Economic Commission for Europe**Inland Transport Committee****World Forum for Harmonization of Vehicle Regulations****163rd session**

**1958 Agreement – Consideration of draft amendments
to existing Regulations submitted by GRSP****Proposal for Supplement 1 to Regulation No. 127 (Pedestrian
safety)****Submitted by the Working Party on Passive Safety ***

The text reproduced below was adopted by the Working Party on Passive Safety (GRPE) at its fifty-fourth session (ECE/TRANS/WP.29/GRSP/54, para. 28). It is based on GRSP-54-09-Rev. 1 as reproduced in Annex V to the report. It is submitted to the World Forum for Harmonization of Vehicle Regulations (WP.29) and to the Administrative Committee AC.1 for consideration.

"Figure 3

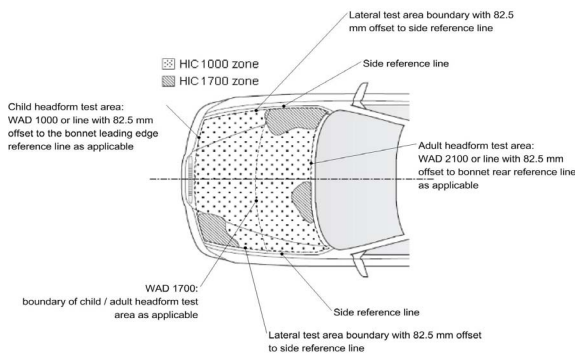
Annex 5, Figure 3, amend to read:

Example of marking of HIC1000 zone and HIC1700 zone

Paragraphs 3.4.2. to 3.4.4., amend to read:

"3.4.2. Marking of the "bonnet top test area" as well as "HIC1000 zone" and ...

3.4.3. The areas ... by the measuring point.
